# City of Malibu

## GEOTECHNICAL REVIEW SHEET

<b>Date:</b>	March 22, 2019	<b>Review Log #:</b>	3701
<b>Site Address:</b>	22959 Pacific Coast Highway		
<b>Lot/Tract/PM #:</b>	n/a	<b>Planning #:</b>	CDP 09-067
<b>Applicant/Contact:</b>	Joseph Lezama, joseph@buaia	<b>BPC/GPC #:</b>	
<b>Contact Phone #:</b>	310-456-5905	<b>Fax#:</b>	
		<b>Planner:</b>	Adrian Fernandez
<b>Project Type:</b>	Revised project: New three-level Malibu Inn Motel, grading, retaining walls with soldier piles and tie-backs, subterranean parking, new onsite wastewater treatment system (OWTS)

The referenced OWTS design report and OWTS plans were reviewed by the City from a geotechnical perspective. The revised project includes constructing a 7,703 square foot three-level motel with 20 lodging units, 46 parking spaces with 24 extra with stacked parking system, grading (11,752 yards of cut under structure: 837 yards of cut and 319 yards of fill non-exempt; and 12,270 yards of export), rear yard retaining walls with tie-back stabilization/soldier piles, terraces and landscaping on the rear-yard ascending slope, and a new onsite wastewater treatment system (OWTS) in the front parking area consisting of a treatment t

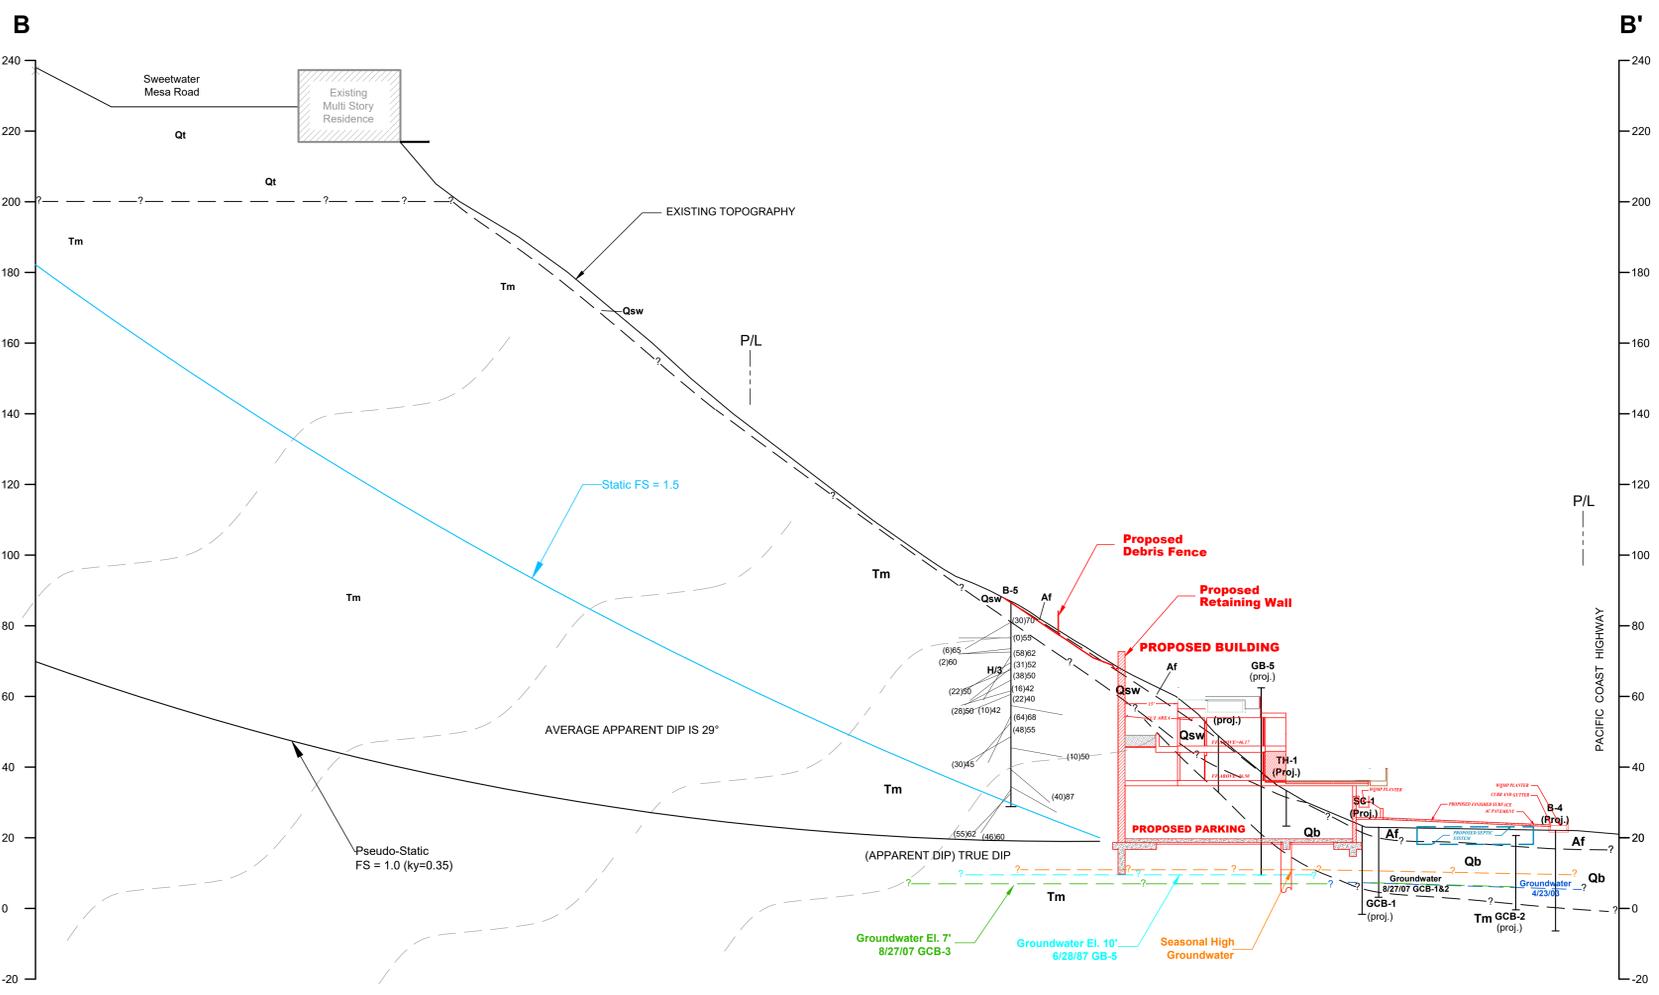
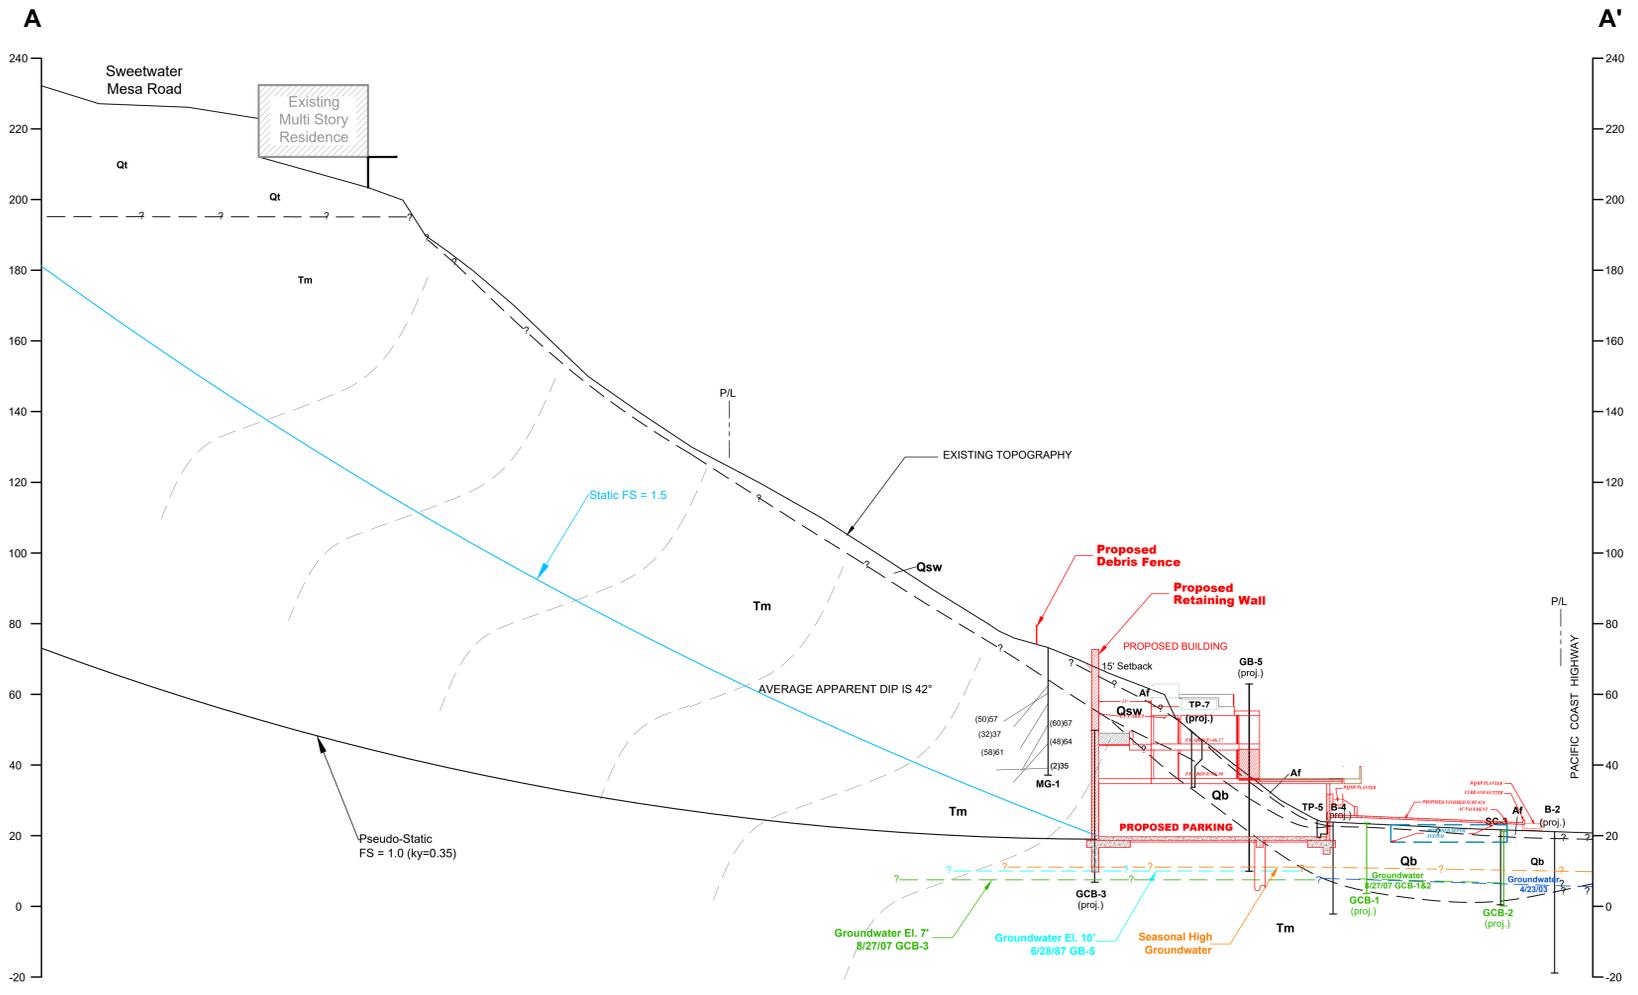
1. The Project Geotechnical Consultant shall provide a discussion of the changes in the proposed development based on the revised plans for the motel.
2. Please update the cross-sections to show the proposed grades on the three levels of the motel based on the current grading plans. They do not appear to match. Provide additional recommendations, as appropriate.

Item 1: The previous freeboard recommendation was four feet. Cross Sections A-A' and B-B' show four feet of freeboard on the retaining wall. The 15 foot slope setback is shown on the Cross Sections as well. In addition, a debris fence was recommended on the slope above the wall. The proposed debris fence is shown on the attached Geologic Map and on Cross Sections A-A' and B-B'. A detail for a Geobrug SL debris fence is attached.
